RE: Saranam Golf Course & Montano
4701 Montano Rd NW
Grading and Drainage Plan
Engineer's Stamp Date: 2/15/2022
Hydrology File: E11D013B

Based upon the information provided in your submittal received 2/16/2022, the Grading & Drainage Plan **is not** approved for Building Permit. The following comments need to be addressed for approval of the above referenced project:

**RE: Saranam Golf Course & Montano
4701 Montano Rd NW
Grading and Drainage Plan
Engineer's Stamp Date: 1/4/2022
Hydrology File: E11D013B**

**RE: Saranam Golf Course & Montano
4701 Montano Rd NW
Grading and Drainage Plan**

* Existing pond volume obtained from As-builts file E11_D13A (11/22/2002)

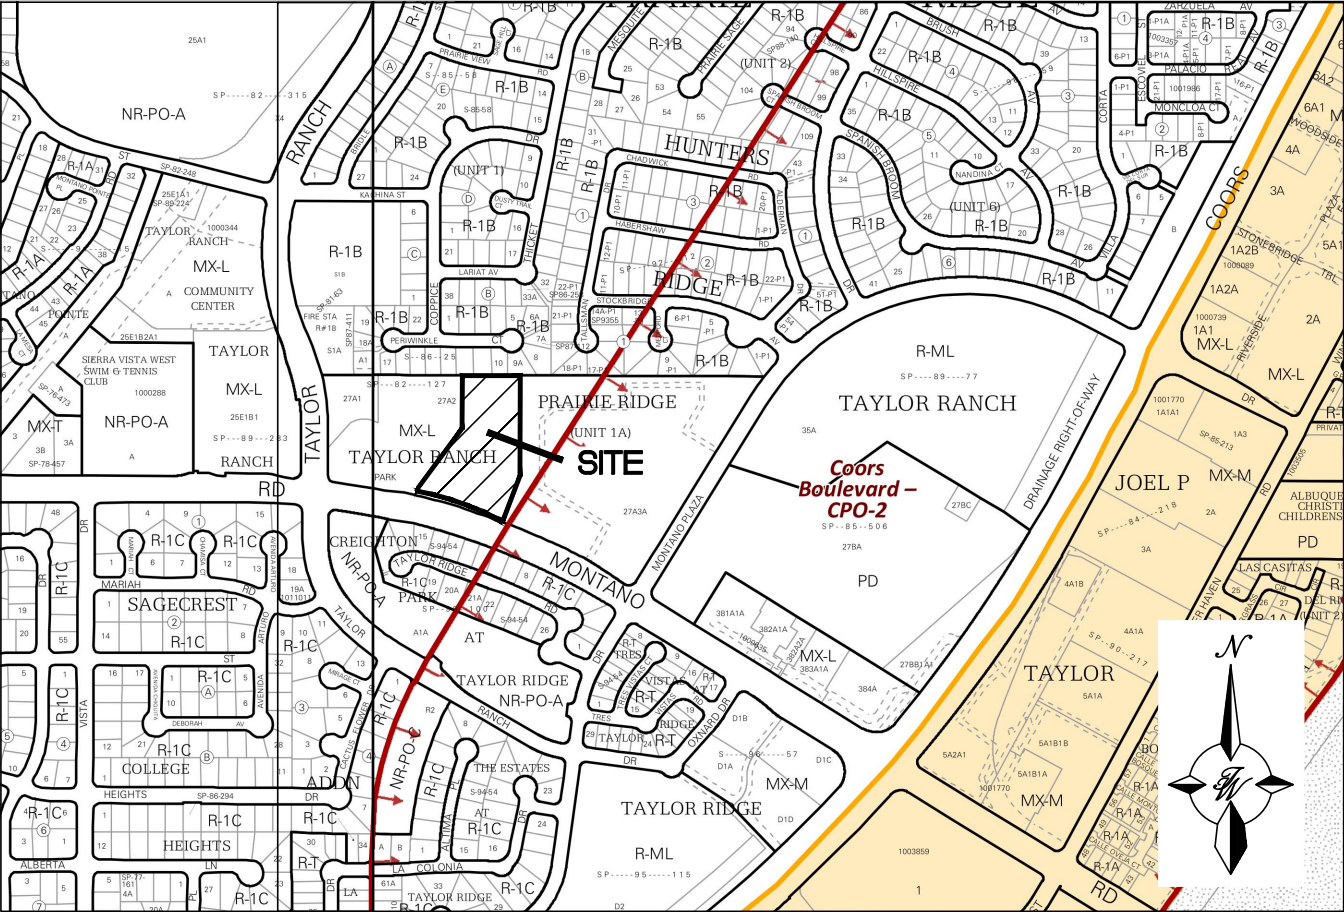
1. Please double check the calculations for the tables provided. I checked a couple and did not come up with the same.
2. Please include the required volume for retention. (100-year, 10-day storm)

Response: Calculations updated to new DPM chapter 6 requirements.

2. Please include the required volume for retention. (100-year, 10-day storm)
Response: Required volume included in sheet C2.1.
